STATE OF NORTH CAROLINA
DEPARTMENT OF TRANSPORTATION

June 26, 2015

SUBJECT: **Request for Modification to the Section 404 Individual Permit and Section 401 Water Quality Certification** for the proposed Greensboro Eastern Loop from US 70 Relocation to SR 2303 (Lawndale Drive), Guilford County, Division 7. WBS Element No. 34821.1.1, TIP Nos. U-2525B and U-2525C.

PERMIT DRAWING SHEET 55 OF 93

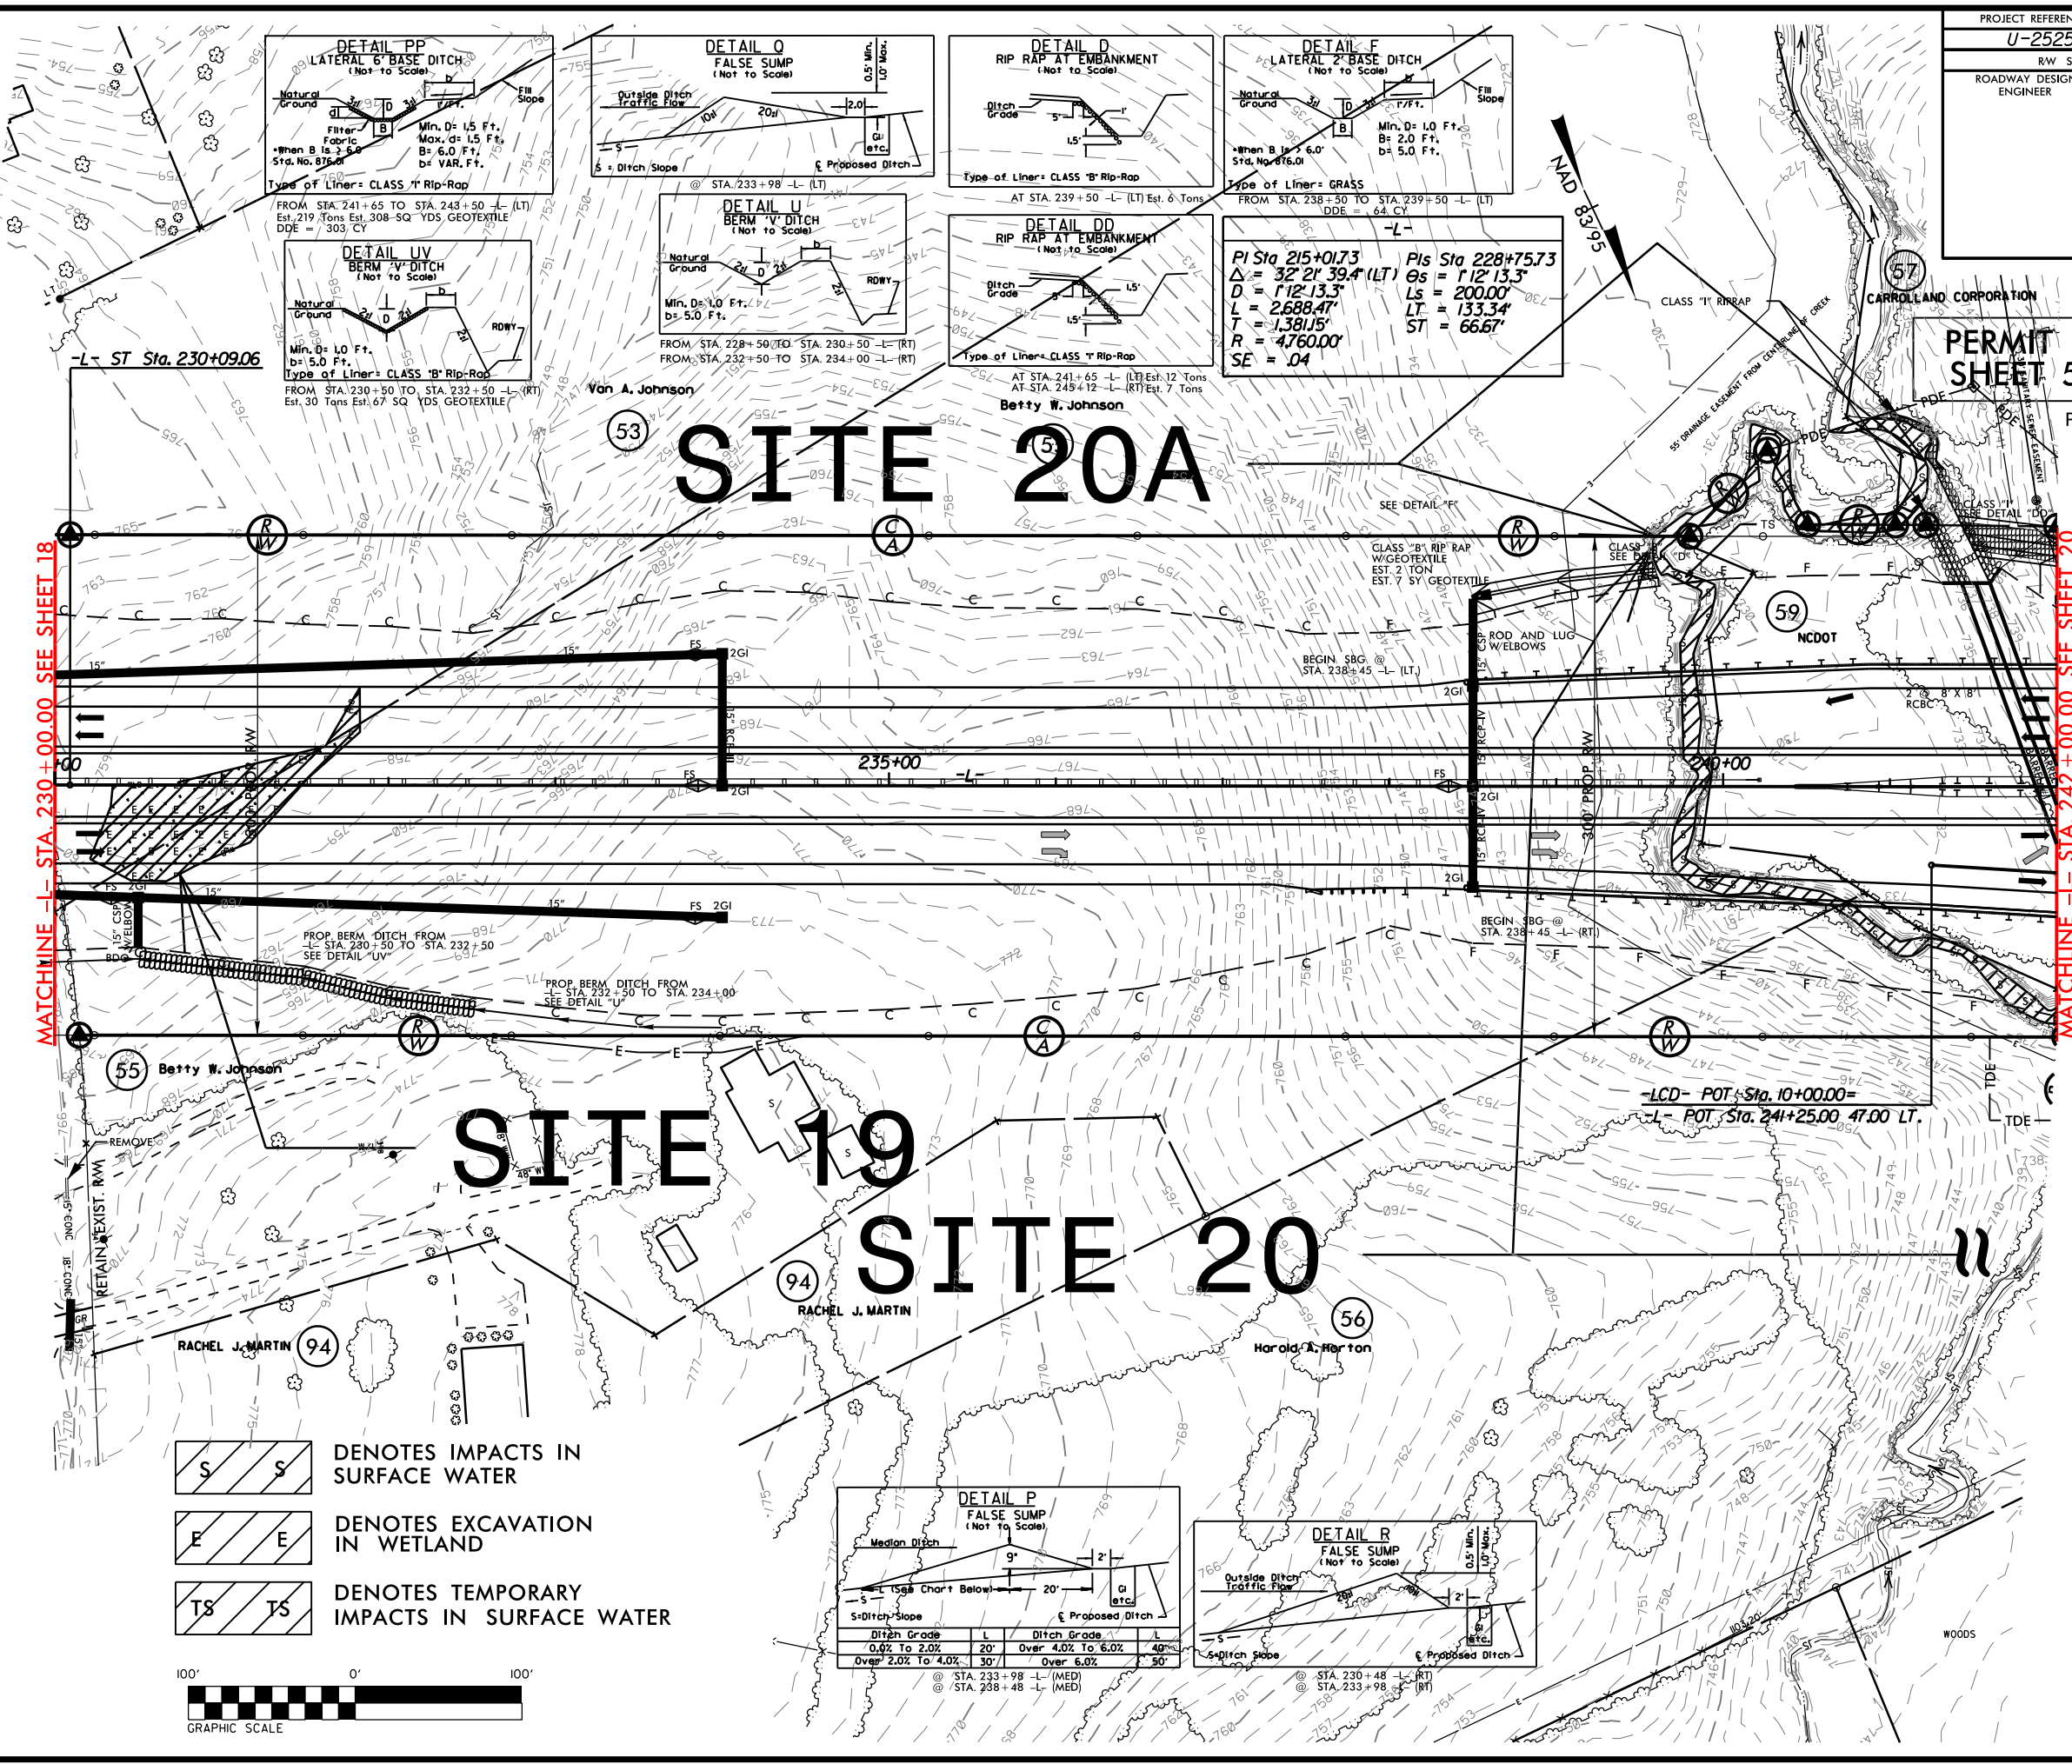
Additional streambank stabilization will also be necessary for Permit Site 10 (35 additional linear feet, offsetting 14 linear feet of temporary impact) and Permit Site 20A (79 additional linear feet, offsetting 29 linear feet of temporary impact). Please refer to the attached revised sheets 32, 33, 54, 55, 79, and 80 for the revised Permit Sites 10, 20A, 31 and 32A impacts. Table 1 below and the attached revised summary table (Sheets 87-93 of 93) have been revised to reflect these revisions.
